ORIGINATION FORM

Proposed Revisions to a Standard Plans Index
(Please provide all information — Incomplete forms will be returned)

Index Number: 700-091

Index Title: Catwalk Details

CATWALK ASSEMBLY
(Cantilever Shown, Span Similar)

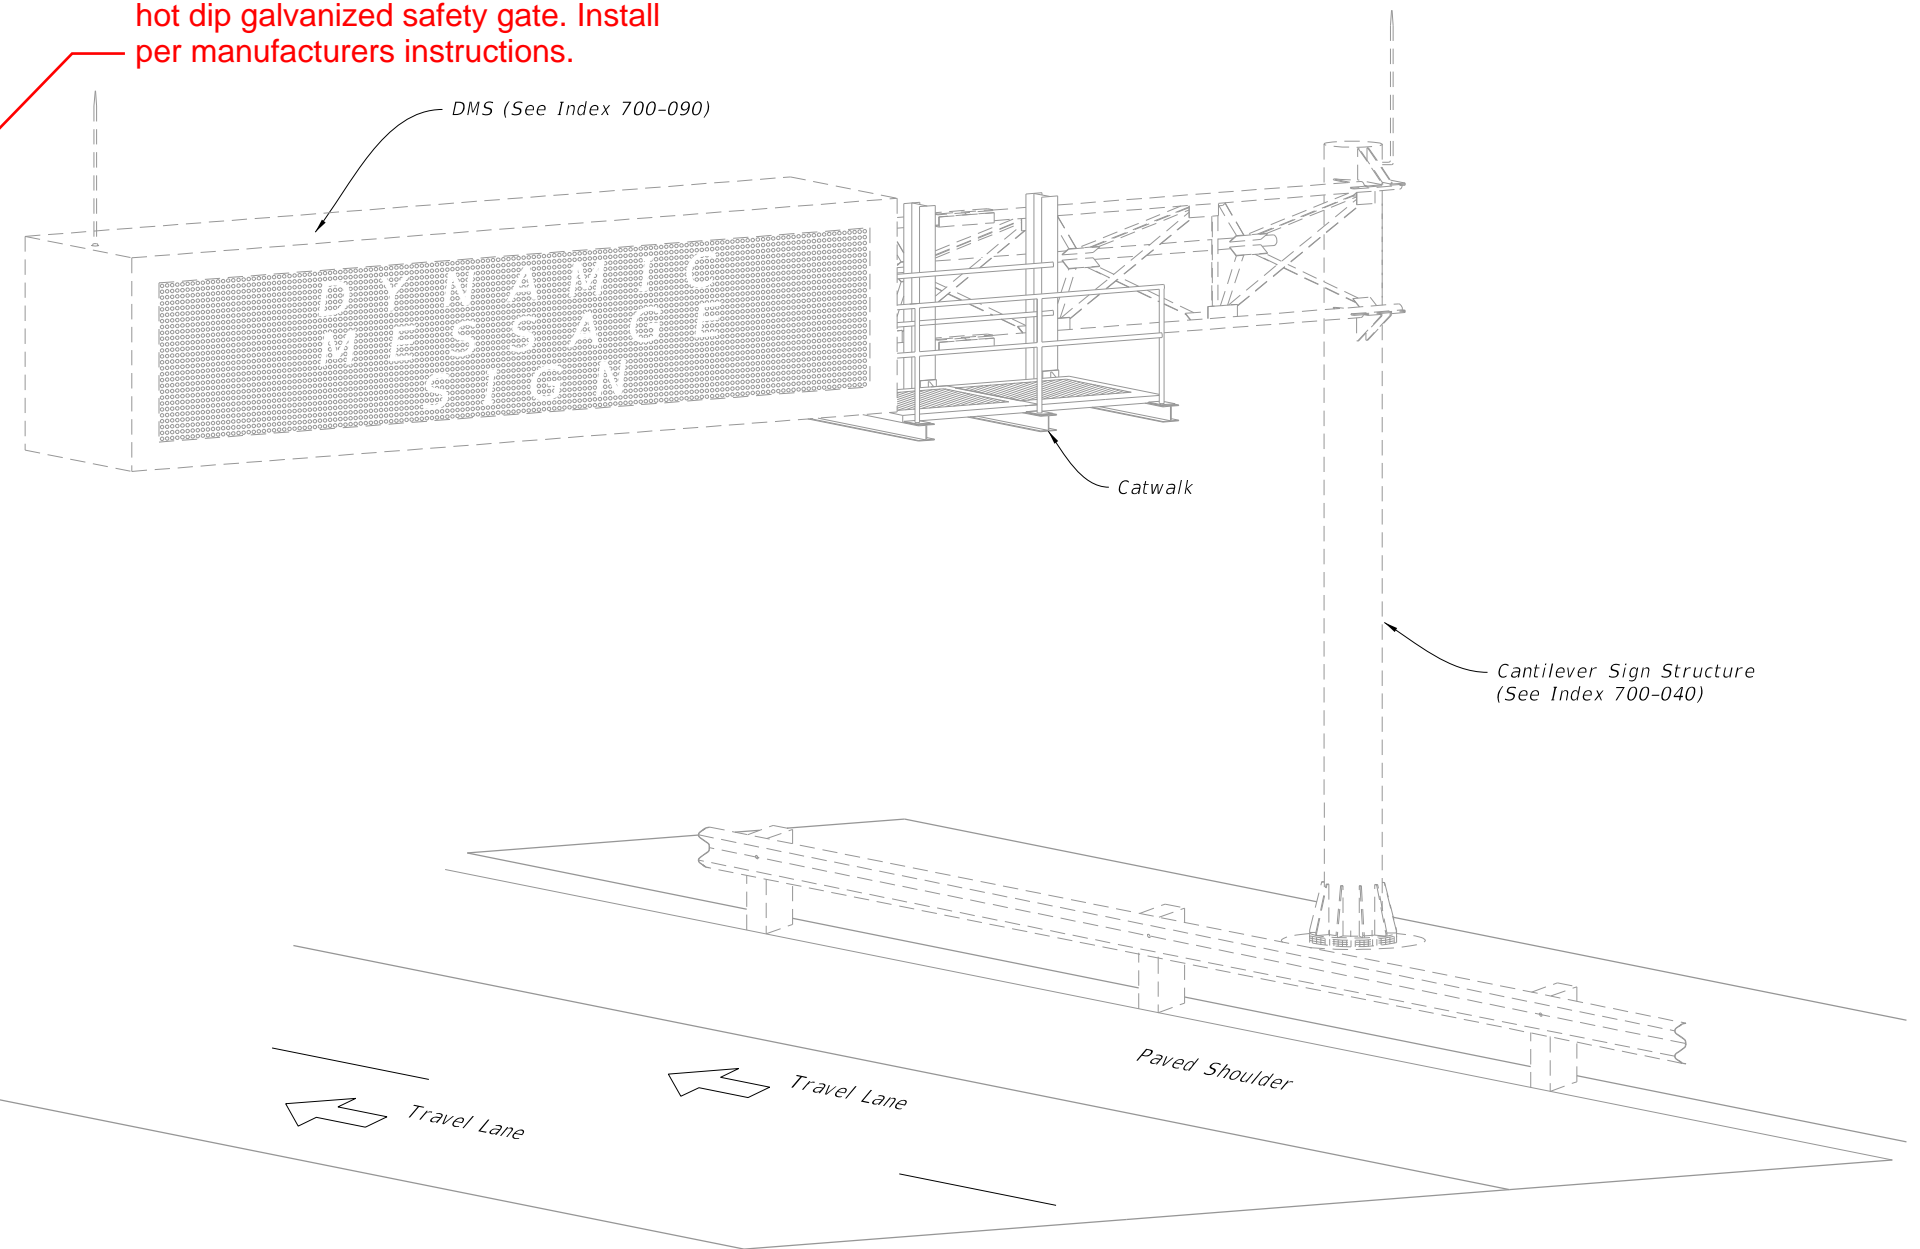
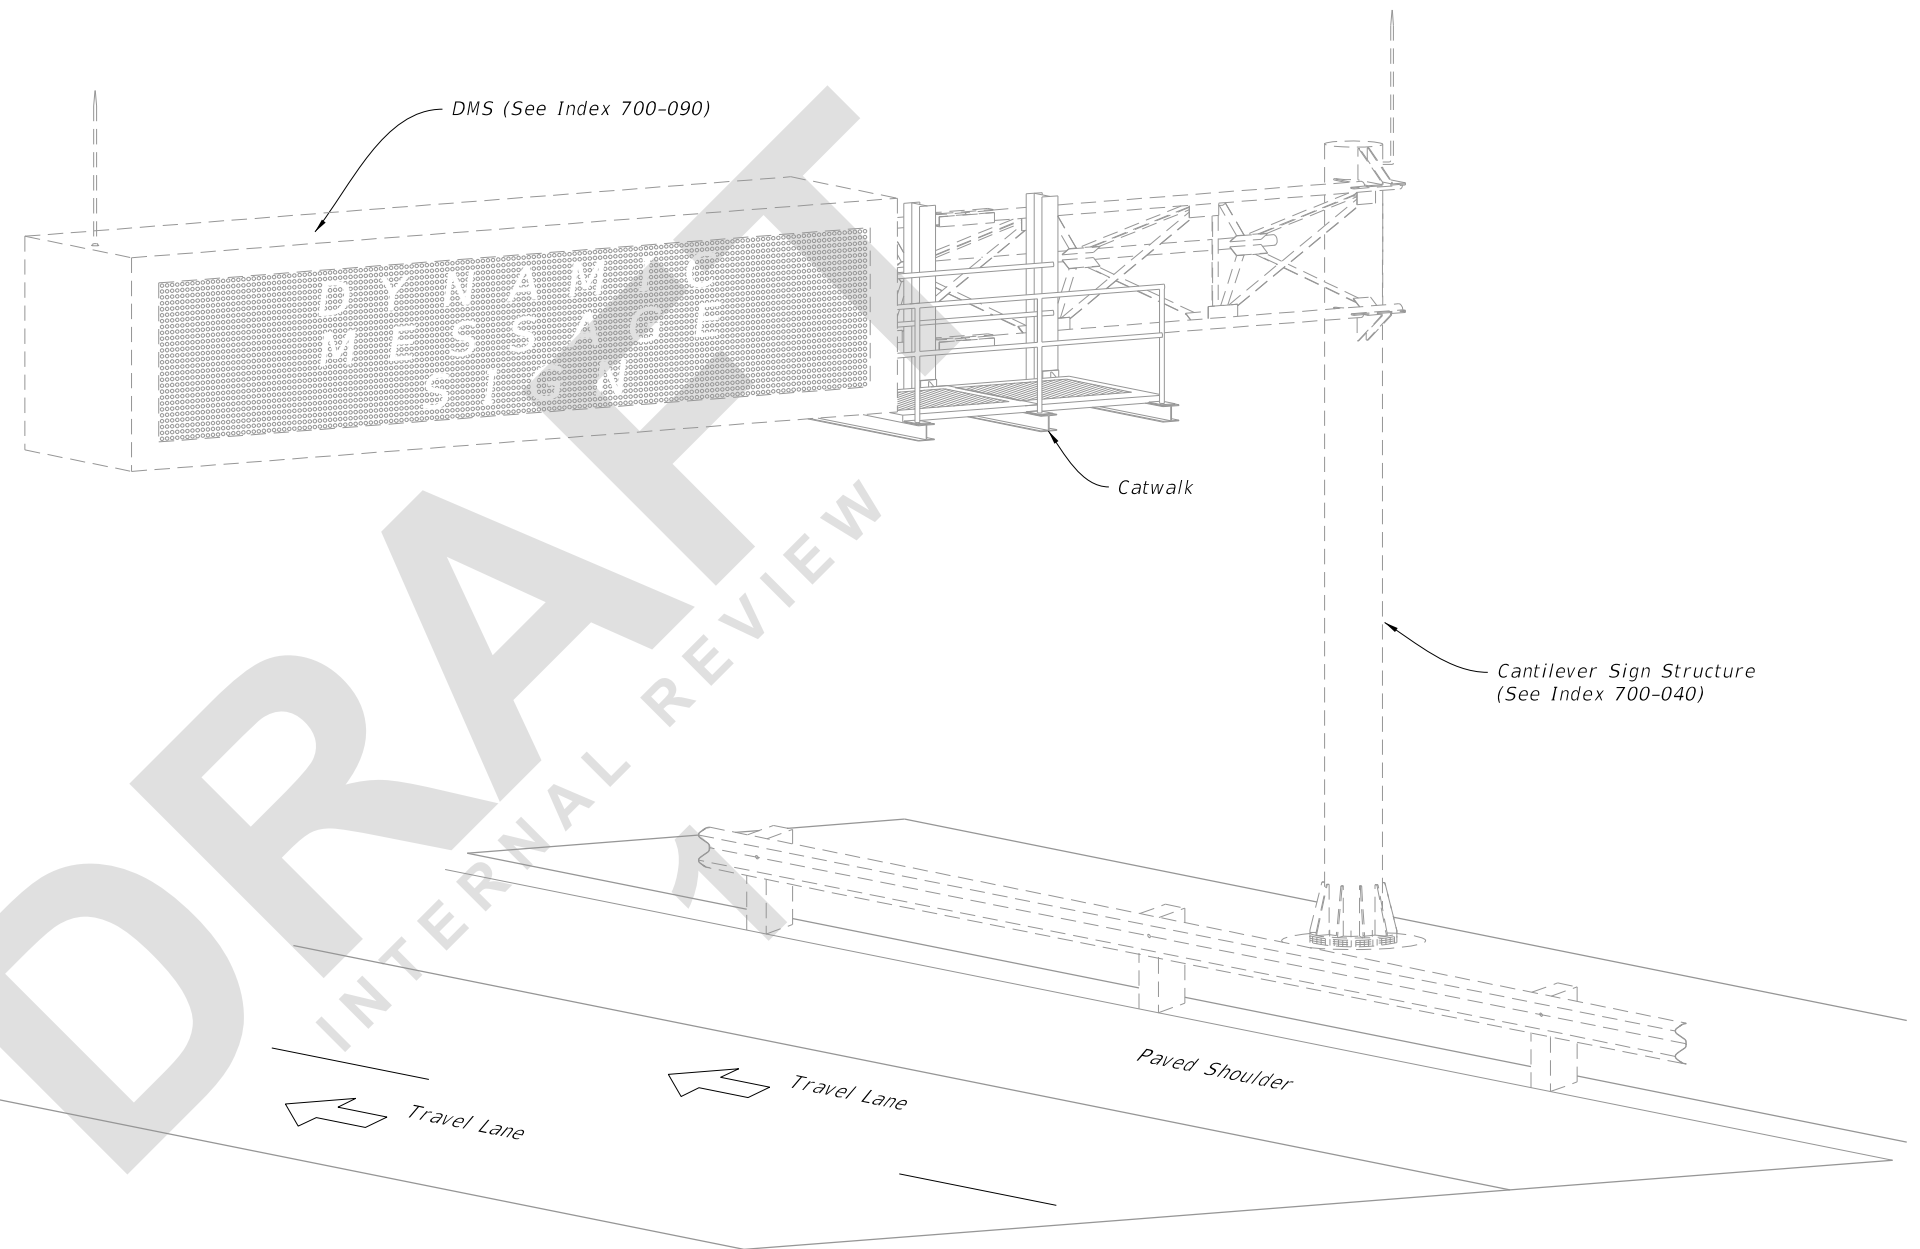
Sheet 1: Updated General Note 6 with more specific language to include Hot Dip Galvanized safety gate and to Install per manufacturers instructions.

6. Supply and install an OSHA 1910 compliant, self closing, ~~corrosion resistant~~ safety gate.
7. Chain link fabric options (2" mesh with knuckled selvage top and bottom for all options):

UPDATE TO:
hot dip galvanized safety gate. Install per manufacturers instructions.

6. Supply and install an OSHA 1910 compliant, self closing, hot dip galvanized safety gate. Install per manufactures instructions.
7. Chain link fabric options (2" mesh with knuckled selvage top and bottom for all options):
